Oakdale West Estate Development Kemps Creek

Civil, Stormwater and Infrastructure Services Report SSDA Modification No. 6

CLIENT/ GOODMAN PROPERTY SERVICES (AUST) PTY LTD DATE/ OCTOBER 2020
CODE/ REP004-01-15-272

Document Title	Oakdale West Design Report – MOD 6
Document File Name	REP004-01-15-272-MOD 6 Civil Report.docx
Section	AT&L - Engineering Division
Document Author	Alex Lohrisch

Figure 1 – Previously Approved Modification No. 3 (left) and Modification No. 6 (right)

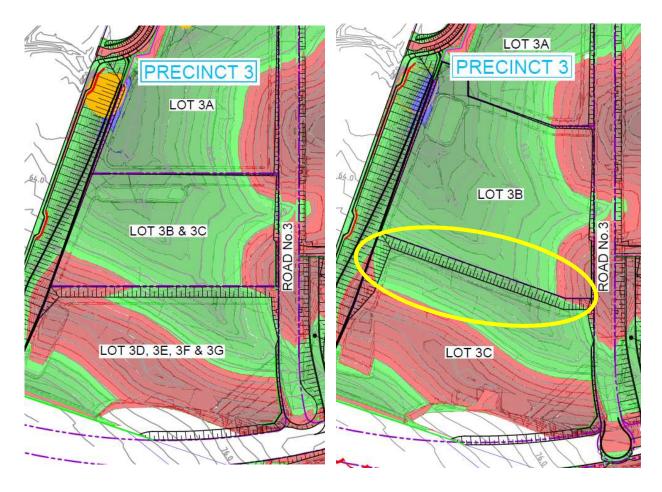
Ultimately the pad levels and retaining walls are unchanged, however are slightly modified to the match the change in lot shape. Road 8 earthworks have also been updated to suit the detailed design. The resulting bulk earthworks volumes are shown in Table 3 below. The total balance or import of fill is shown by the cell highlighted in bold. This can be compared to the respective cell in Stage 1 Approval (495,833m3), Modification No. 1 (748,501m3), Modification No. 2 (632,387m3) and Modification No. 3 (505,865m3). The import volume remains similar to Modification No. 3:

For ease of coordination, a comprehensive Estate-wide set of bulk earthworks drawings have been prepared which are intended to replace the previous Stage 1 approved drawings in Modification No. 3. They are compared below, so it is possible to see how minor the earthworks surface changes are.

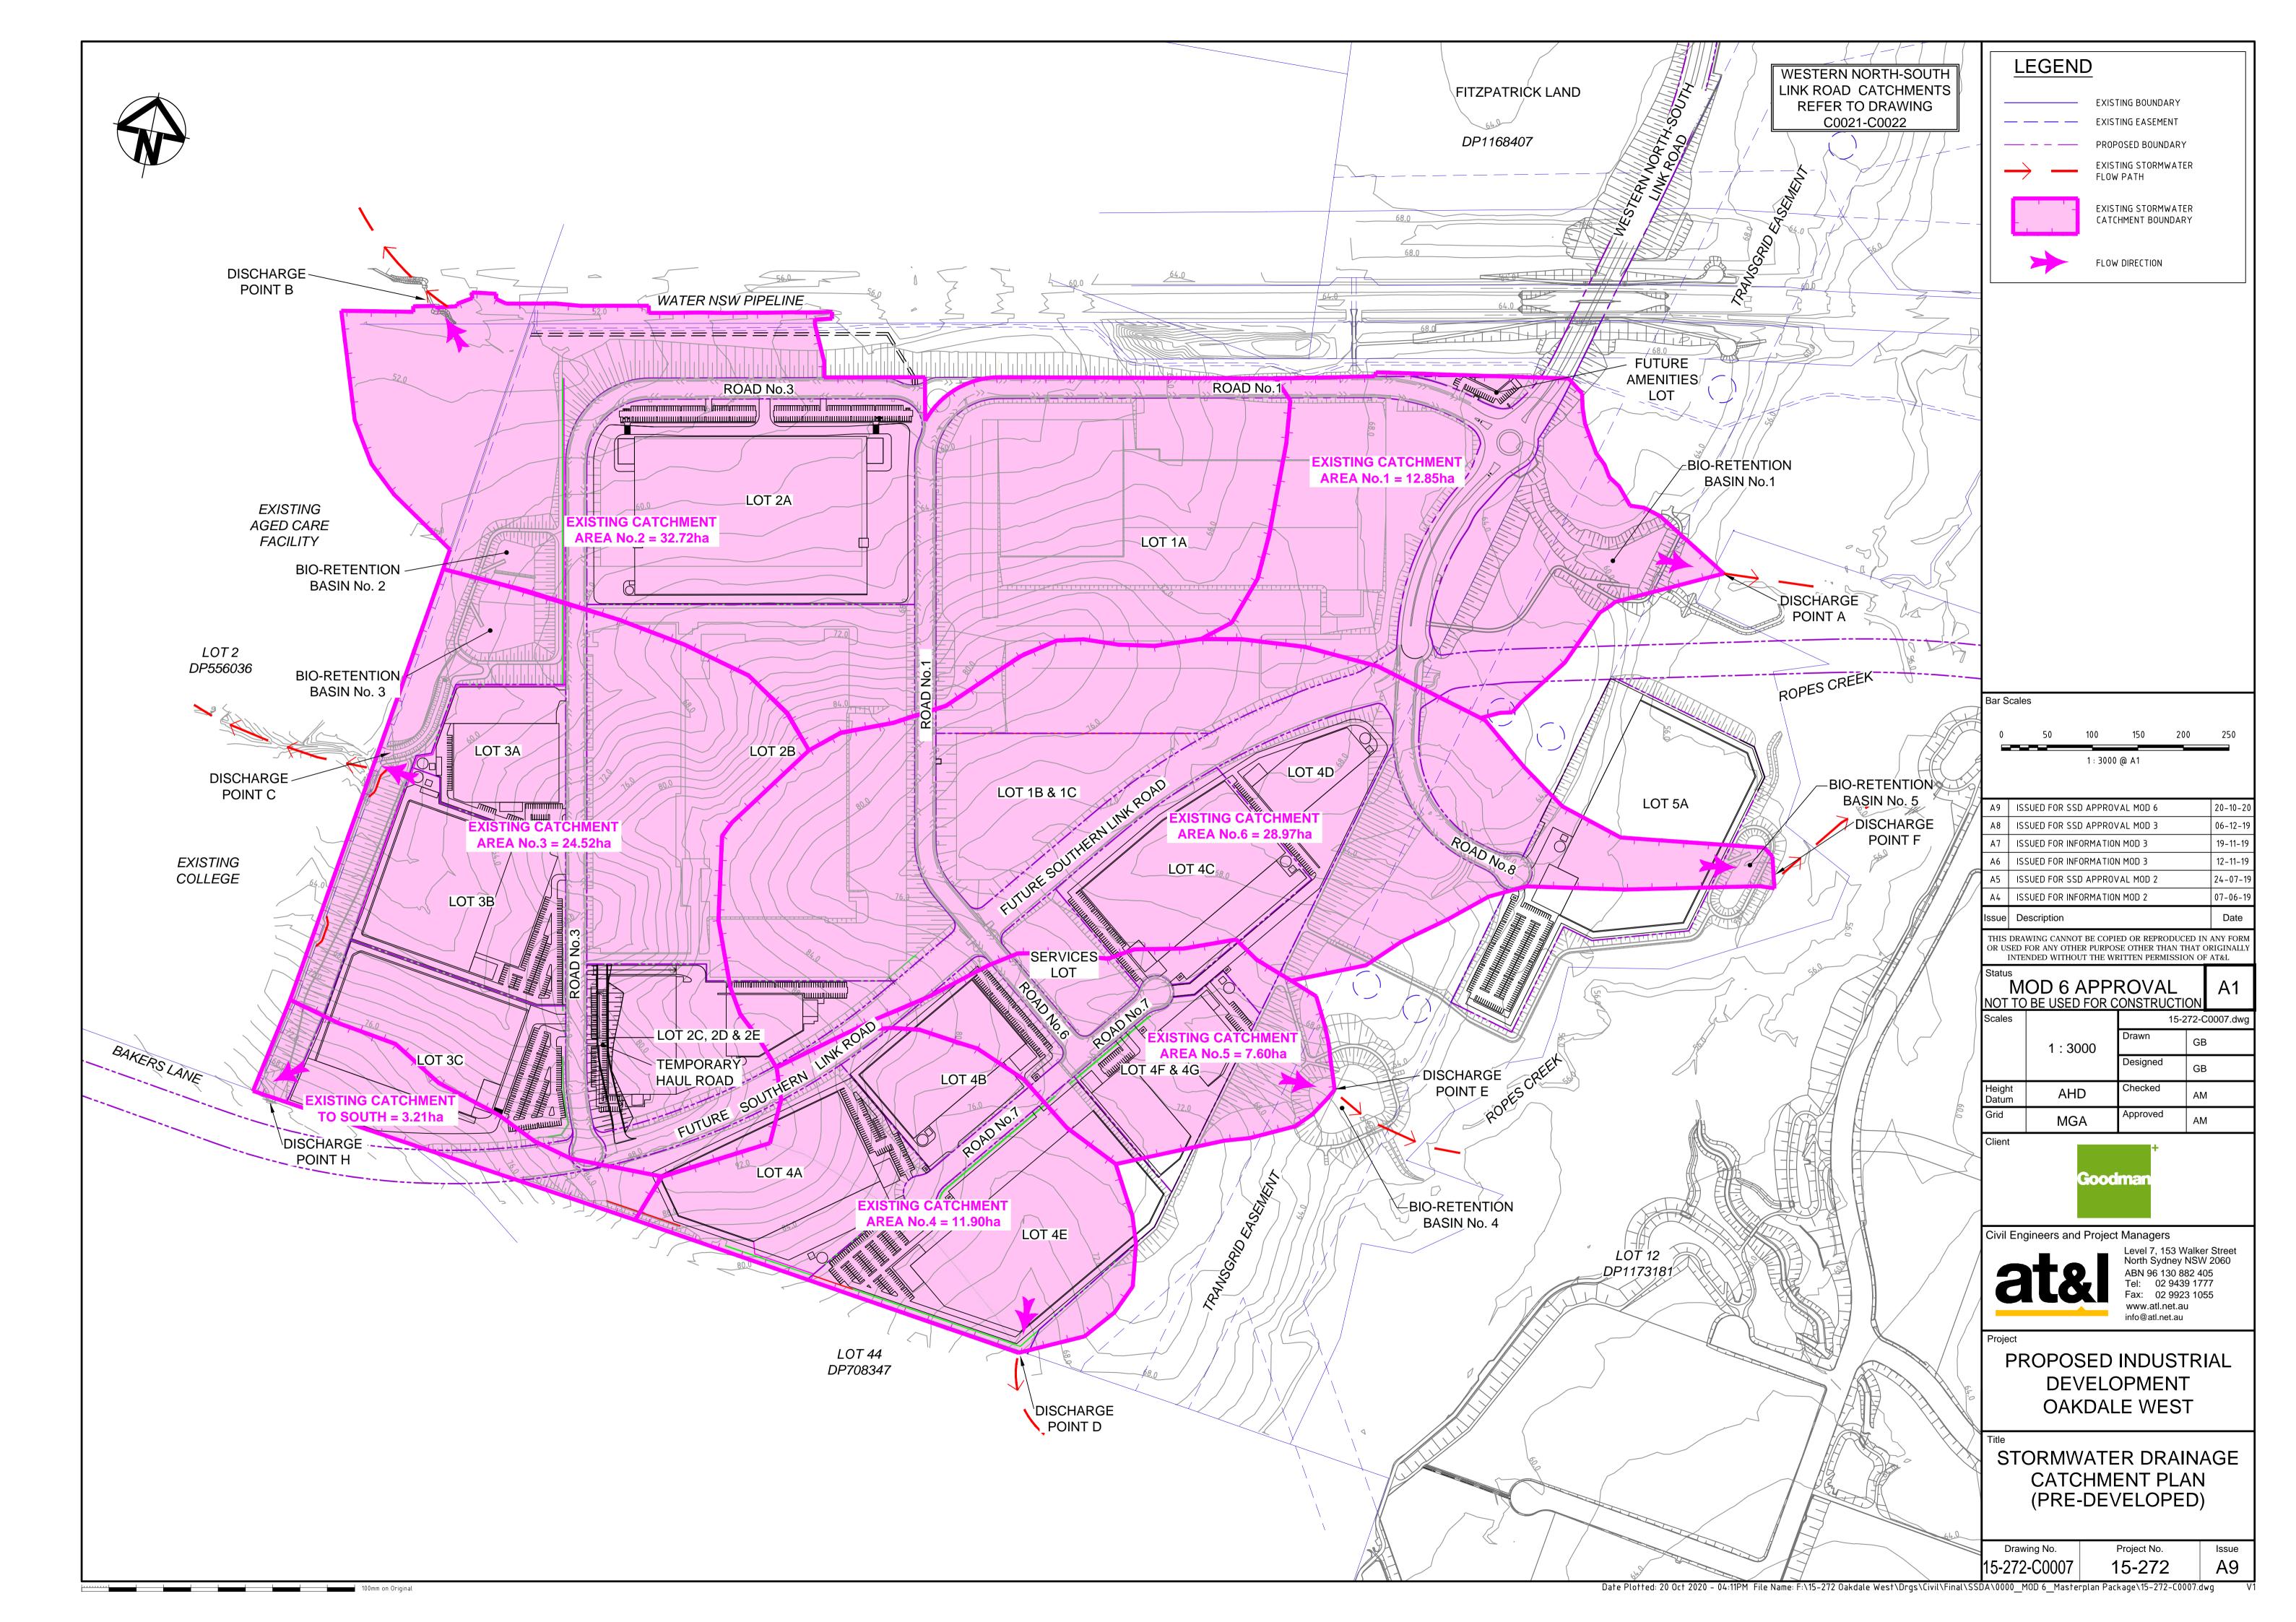
As stated above, Road 8 has always been considered in the assessment of SSDA 7348. Transgrid original consultation and requirements are still applicable as their development guideline. These requirements, such as limiting height of streetlighting to 4.3m, are incorporated into design.

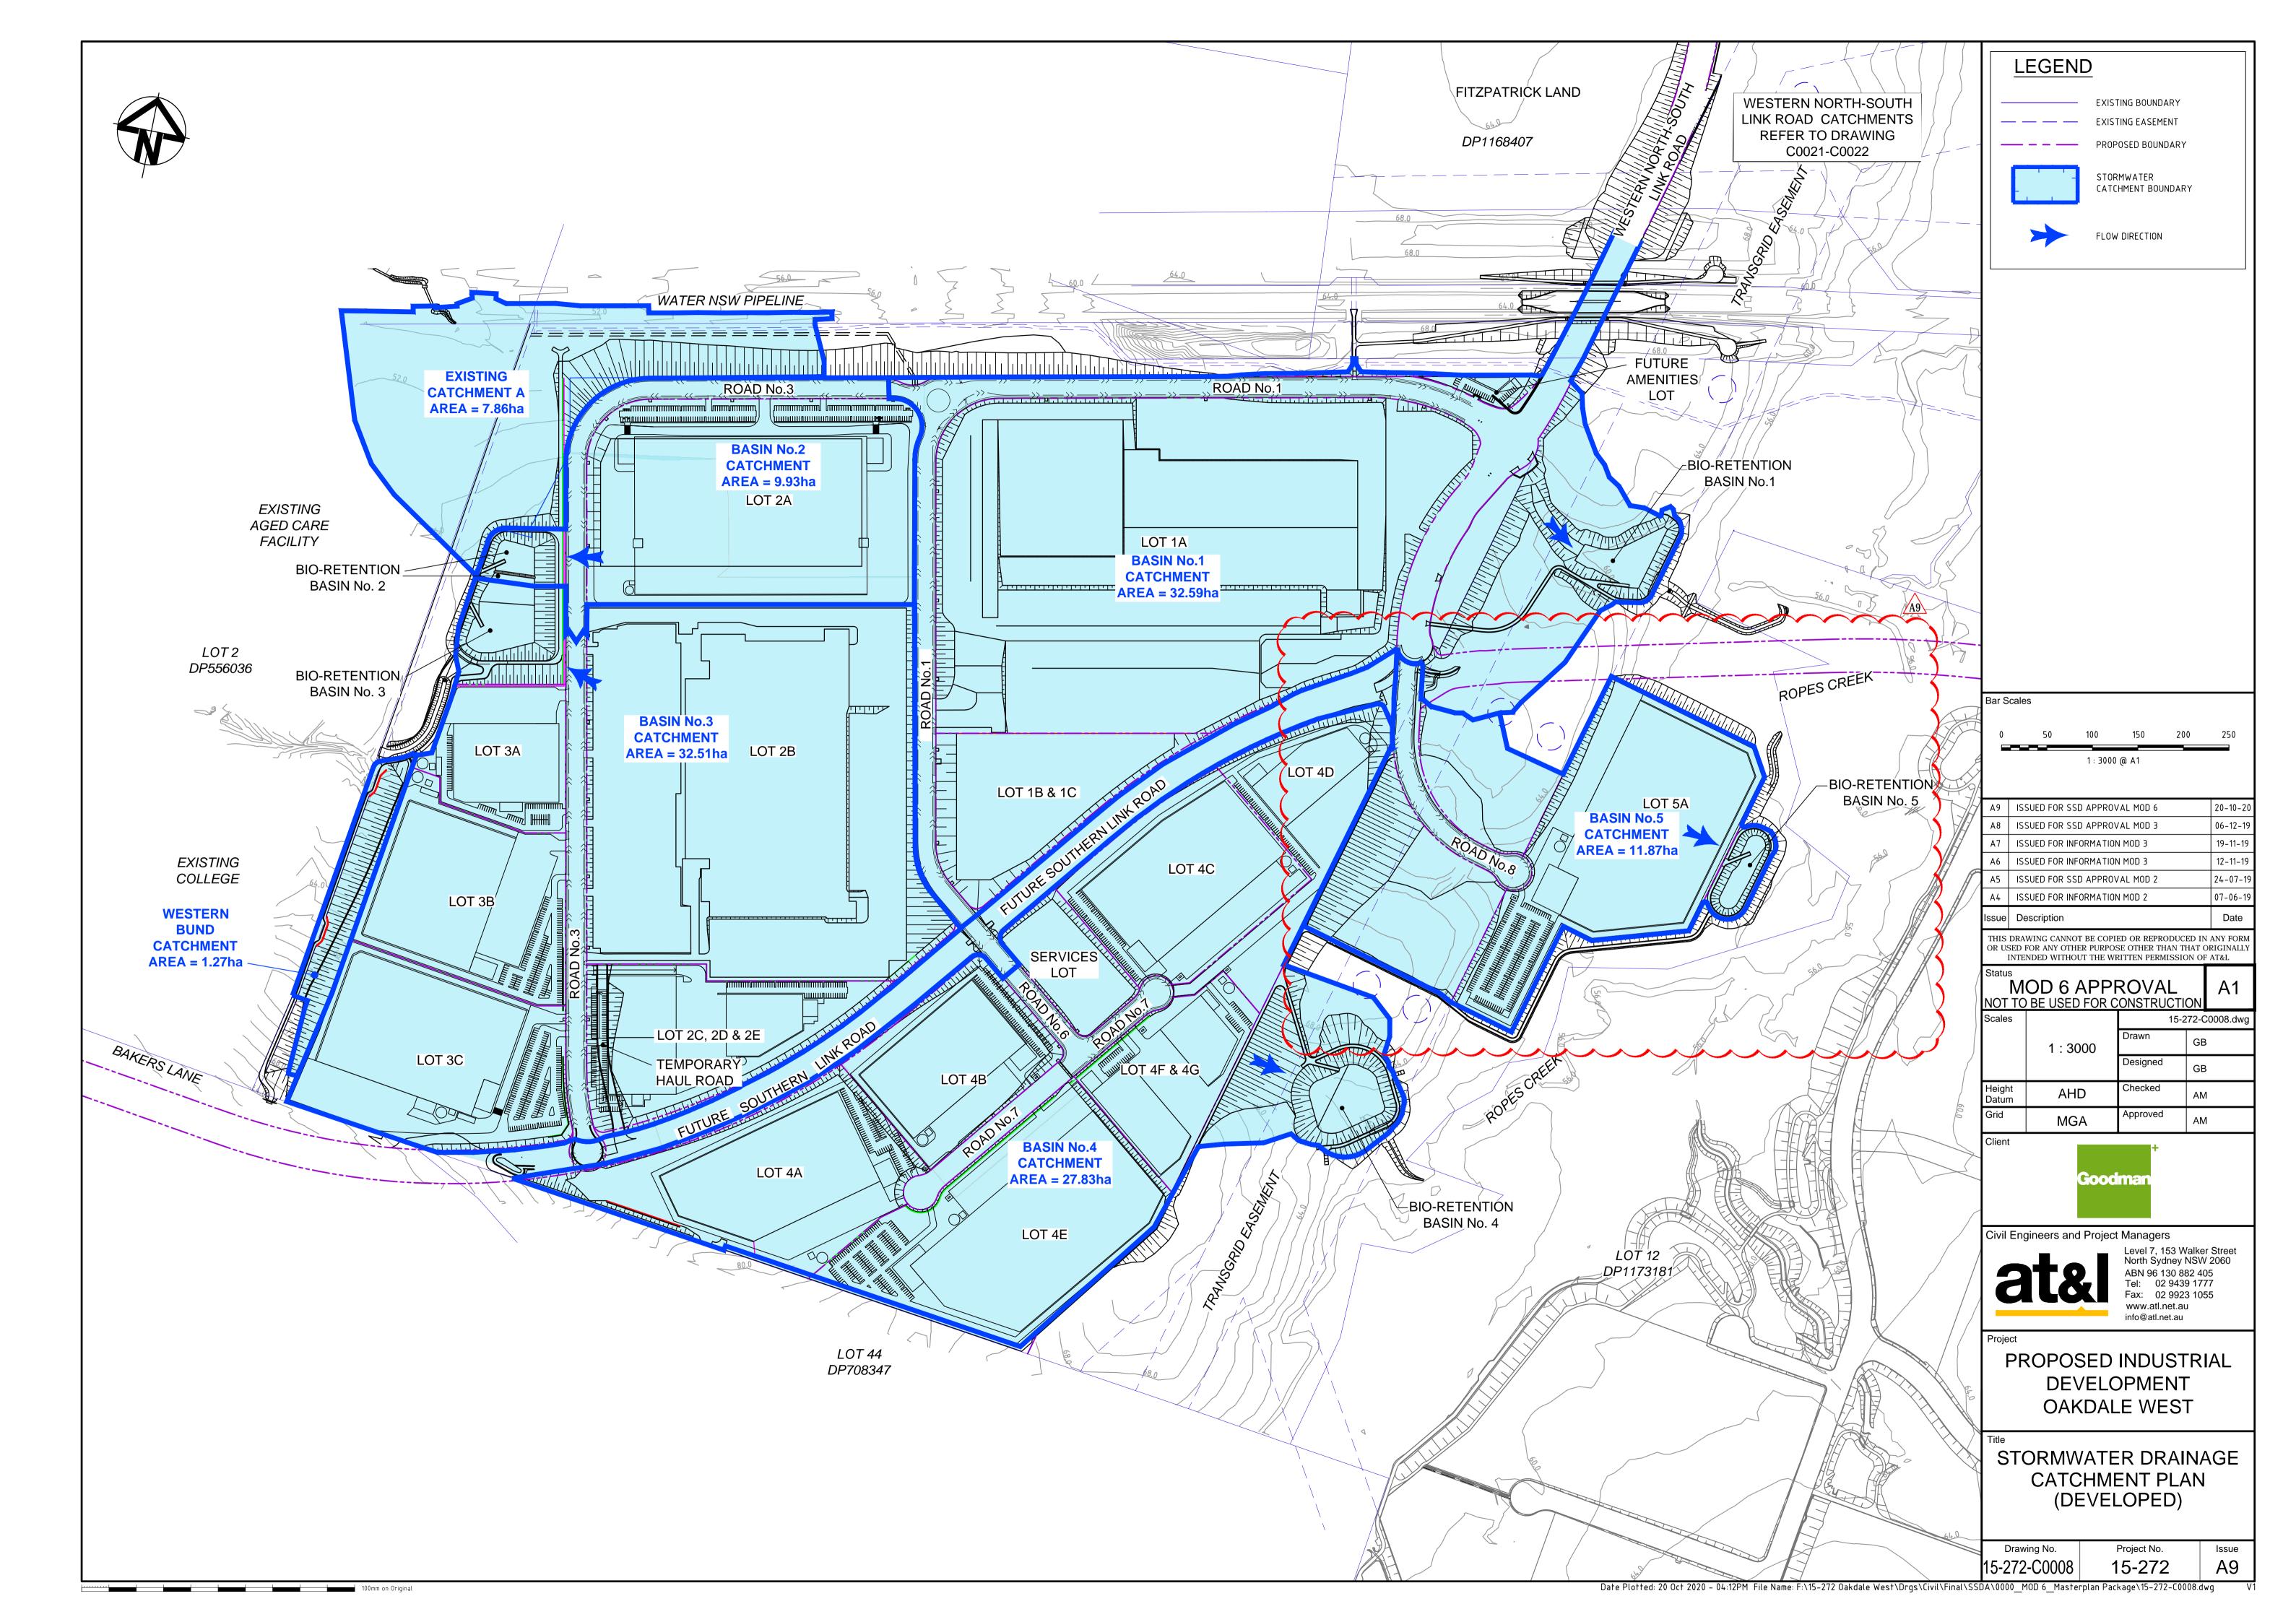
The Road 8 design is not changed in any major way, as it is not more just an inclusion to be built in Stage 1 of construction. Transgrid will however likely review again and provide additional comments to this consent. In consultation, the developer will be urging Transgrid to look at the modification only and not reassess the entire development which is already approved.
